Standards Governing the Design of Curbside Mailboxes

ACTION: Proposed rule.

SUMMARY: The Postal Service proposes to revise USPS STD 7A, which governs the design of curbside mailboxes. The proposed revision was developed through a consensus process and was approved by a committee of representatives from mailbox manufacturers, mailbox accessory manufacturers, and the Postal Service.

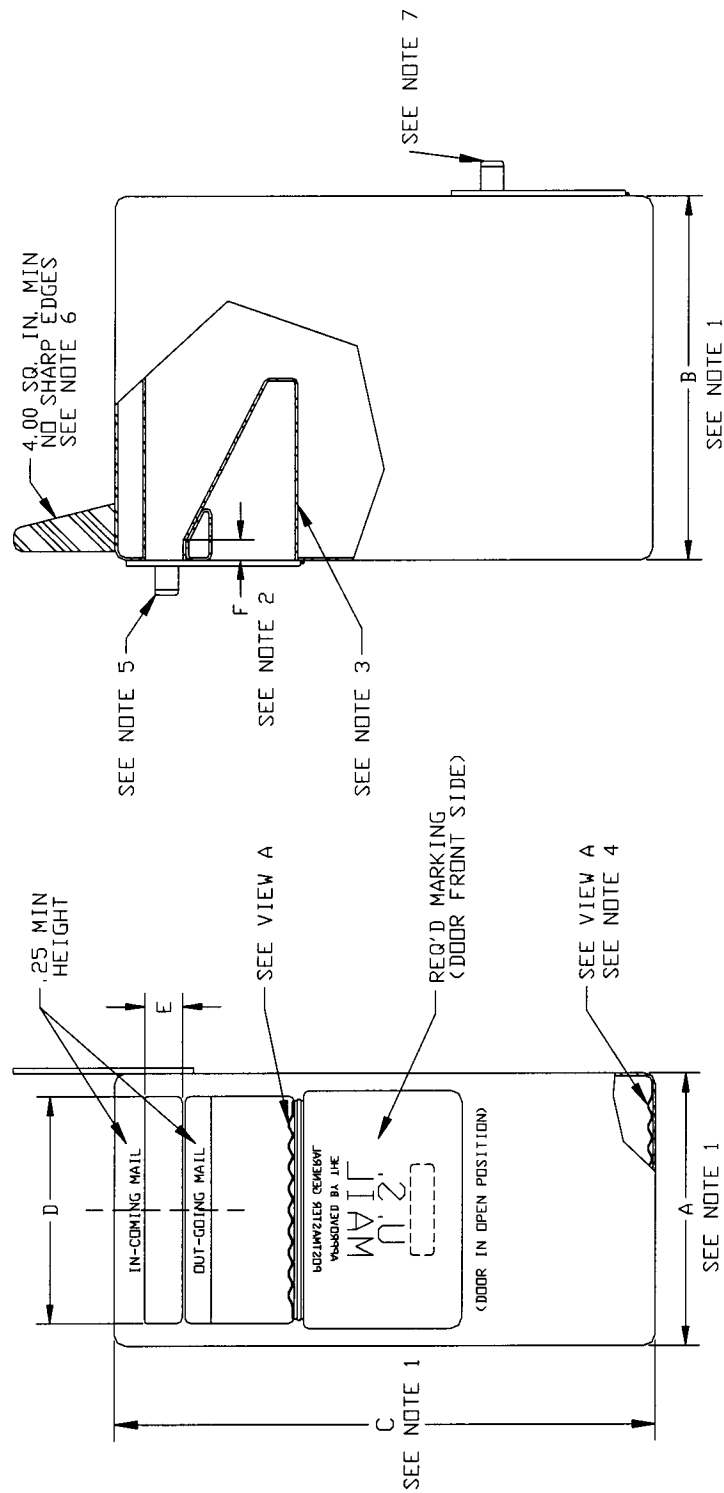
1. Eliminated the requirement that Traditional mailboxes must be built in conformance with USPS drawings (formerly designated T1, T2, and T3). All three USPS drawings were eliminated and replaced with a new figure which gives manufacturers more design flexibility.

Mailbox designs that conform to Figure 1 and meet capacity requirements specified in 3.15.1 will be classified as Traditional. Designs incorporating a carrier signal flag (see 3.7) will be classified as full service mailboxes. Designs with no flag will be classified as limited service (see 3.12.2). As specified in 3.5, a rear door is permitted to enable the customer to remove mail without standing in the street. The use of locks, locking devices, or inserts is prohibited.

LOCKED MAILBOX (FULL SERVICE)
FIGURE 2

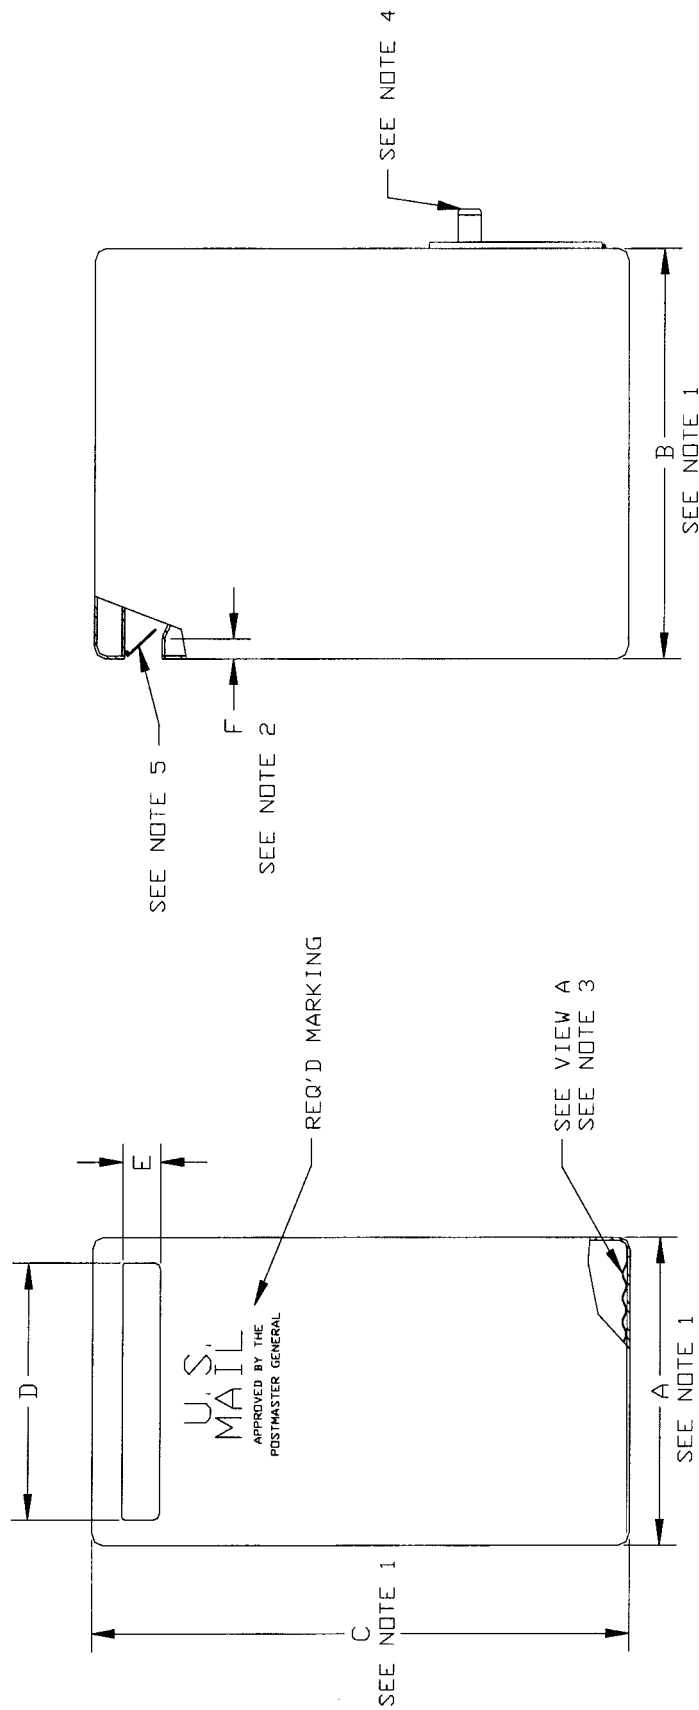
5. Introduced a new Locked mailbox classification with two new figures. This

Locked mailbox designs of this class allow for both incoming and outgoing mail as depicted in Figure 2. It is preferred that both incoming and outgoing mail compartments be located behind a single carrier service door as shown in Figure 2 (the term "preferred" in this document means that compliance is desired but not mandatory). Alternate positioning of the incoming mail compartment, such as beneath or side-by-side with the outgoing compartment, is permitted provided that no additional carrier service is introduced.

FIGURE 3

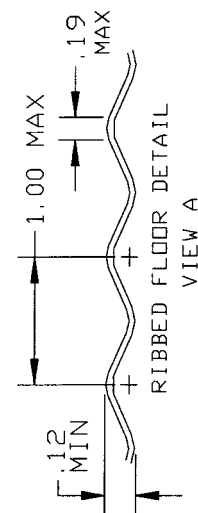
Locked mailbox designs of this class allow only for incoming mail as shown in Figure 3.

ALTERNATIVE FLAG DESIGNS
FIGURE 4

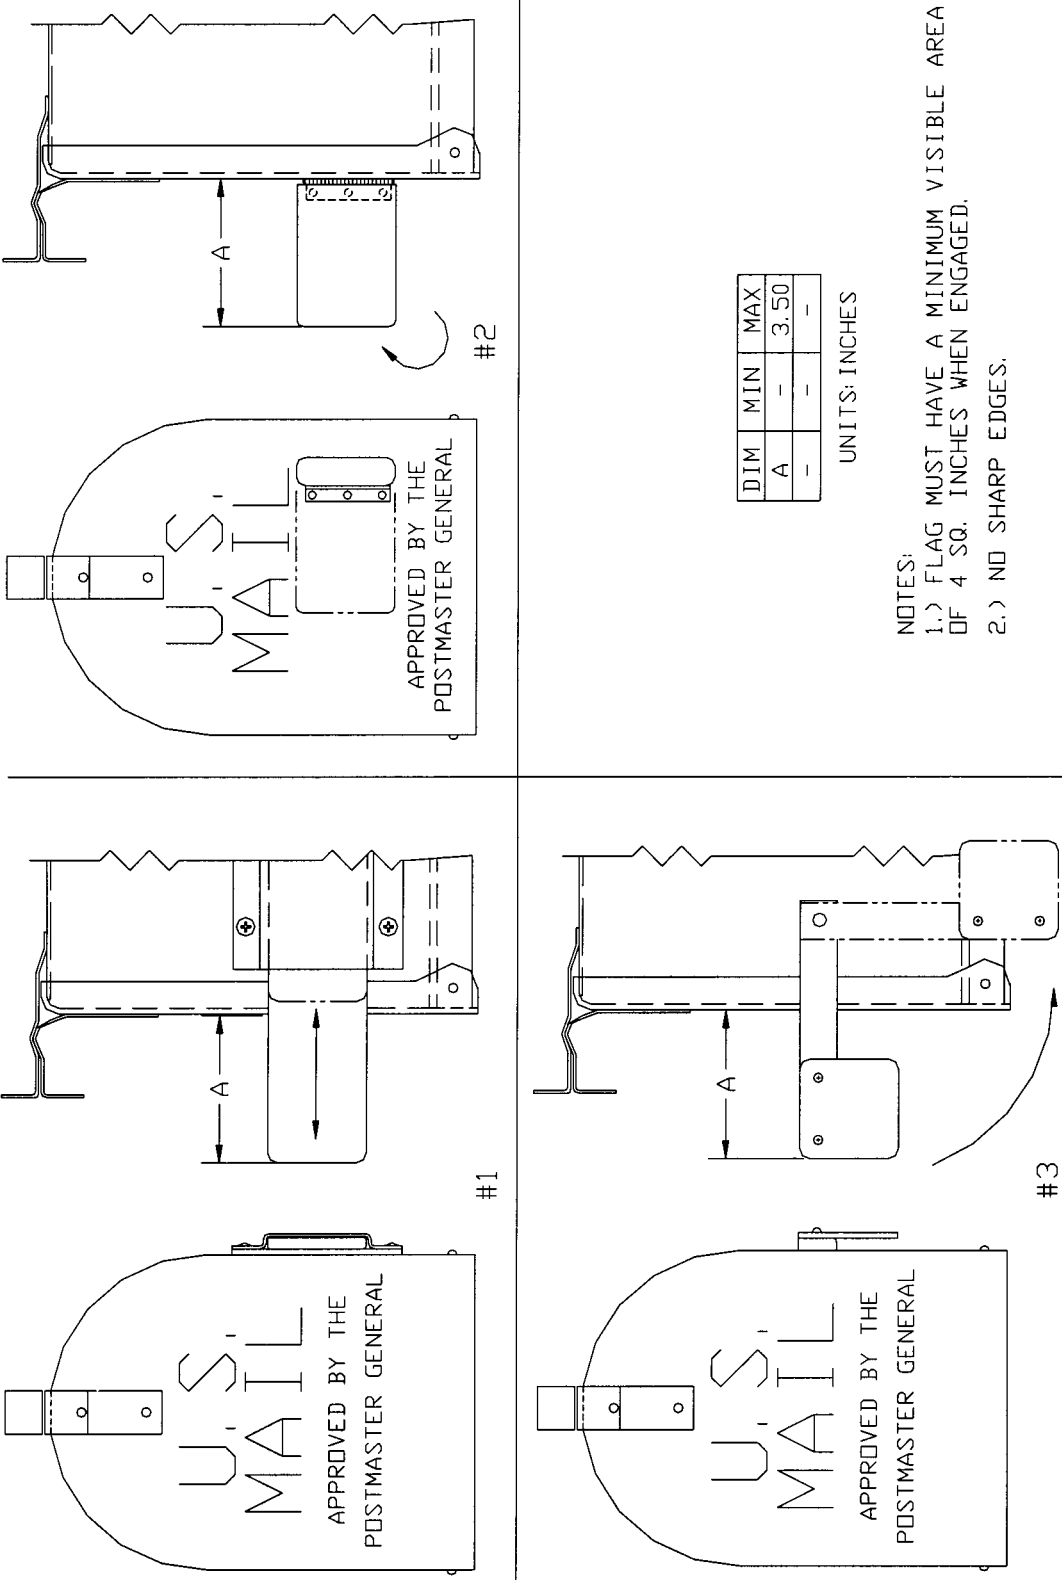
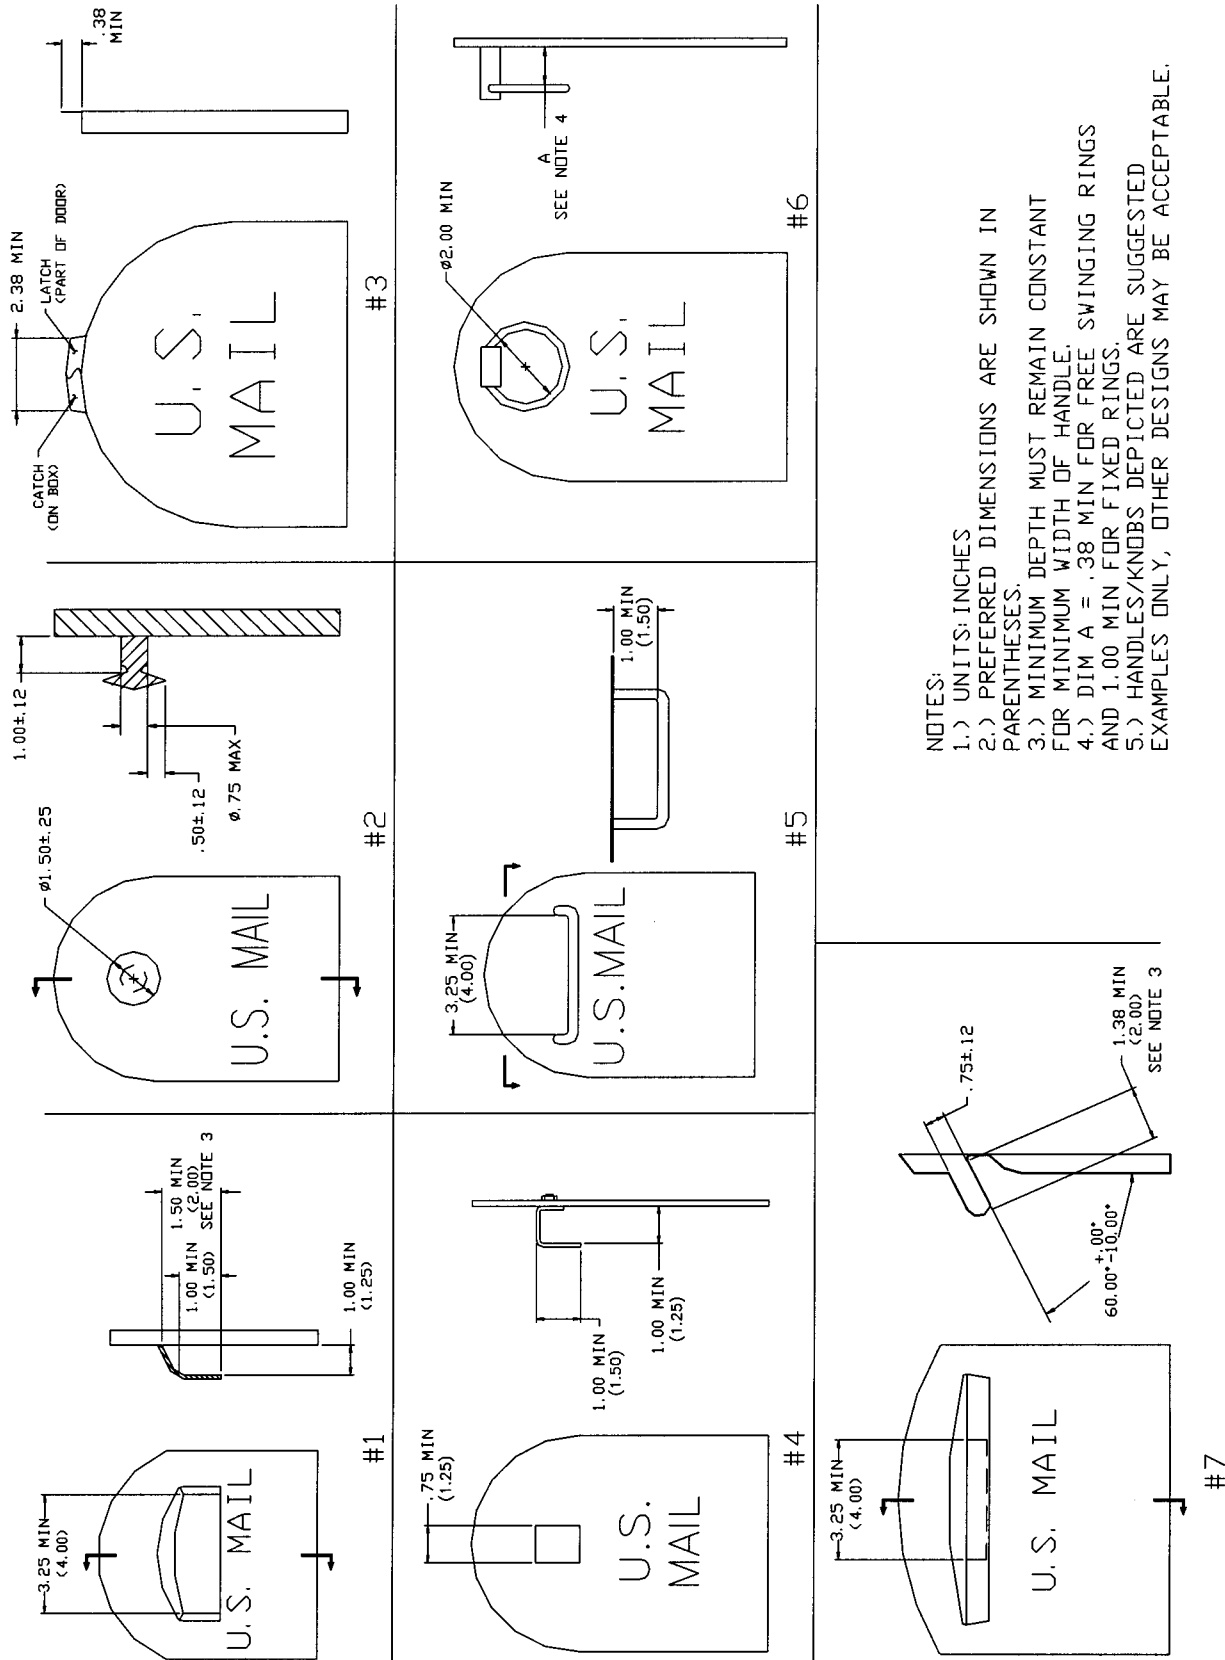
7. Added a figure depicting three new alternative flag designs.

Traditional, Contemporary, and Locked mailbox designs classified as Full Service shall have a carrier signal flag. The flag design must be one of the approved concepts depicted in Figures 1, 2, and 4. As shown in each figure, the flag must be mounted on the right side when facing the mailbox from the front. The flag must not require a lift or more than 2 pounds of force to retract. Additionally, when actuated (signaling outgoing mail) the flag must remain in position until retracted by the carrier. The color of the flag must be in accordance with requirements described in 3.10. The operating mechanism of the flag must not require lubrication and must continue to operate properly and positively (without binding or excessive free play) after being subjected to testing described in 3.15. Optionally, the flag may incorporate a self-lowering feature that causes it to automatically retract

**DIRECTION OF LOADS
FIGURE 6**

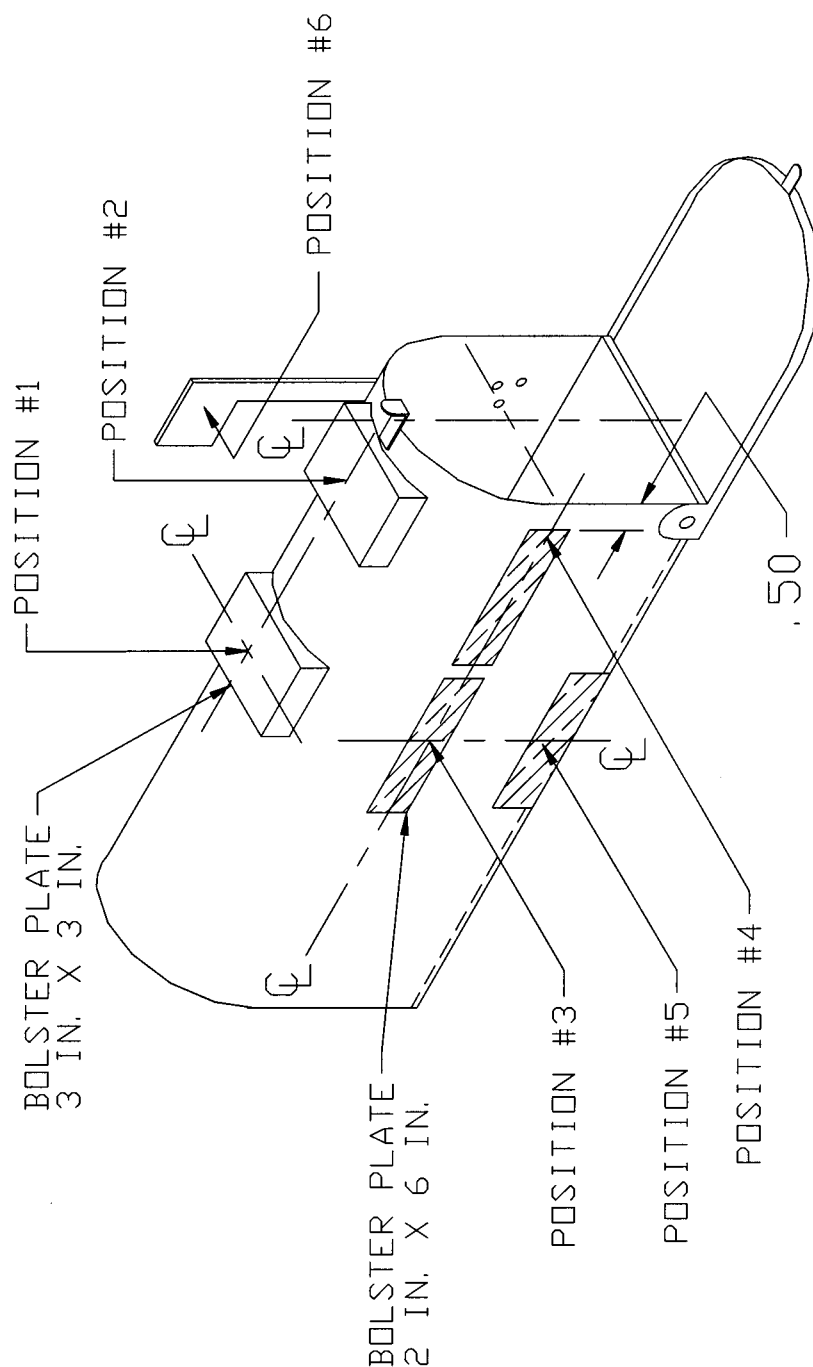
Forces of specified magnitude (see Table II) shall be slowly applied at specific points on the mailbox under test (see Figure 6). These forces shall be held for a minimum of one minute and then released. After their release, the deformation caused by the forces shall be measured. If the deformation exceeds the limit specified in Table II, the mailbox under test has failed to meet the structural rigidity requirement. The doors shall remain closed for test positions one through six. The application of the forces at positions one and two shall be applied with the mailbox in its normal upright position, supported by a horizontal board. The application of the forces at positions three, four, and five shall be applied with the mailbox lying on its side (flag side down). The mailbox shall be supported, on the underside, by a flat board that is relieved in the immediate area of the flag mechanism. The application of force at position six (Traditional style flags only) shall be applied with the mailbox lying on its side (flag side up). The application of force at position six shall be repeated at the top of the flag with the mailbox in its normal upright position. If visible cracks in the material have developed as a result of the testing, the mailbox under test has failed to meet the structural rigidity requirement. At the conclusion of the structural rigidity testing, if the mailbox under test fails to operate normally, as defined by this document, the mailbox under test has failed to meet the structural rigidity requirement. This test is applicable to all mailbox designs.

Refer to Figure 6 for load positions. Precondition the mailbox for four hours at -20° Fahrenheit. The following testing shall be performed within three minutes of removing the mailbox from the temperature chamber. At both load positions three and four, with the mailbox lying on its side (flag side down) with the door(s) closed, apply an impact load equivalent to a 10-pound weight dropped from a height of 3 feet above the mailbox surface onto a bolster plate having a surface not larger than 2 inches by 2 inches. The mailbox shall be supported, on the underside, by a flat board that is relieved in the immediate area of the flag mechanism. If any noticeable perforation, occurrence of sharp edges, or cracking of the material, either inside or outside the mailbox, develops as a result of the impact, or if the door becomes inoperable or fails to close normally, the mailbox under test has failed to meet the impact resistance requirement. This test is applicable to all mailbox designs.
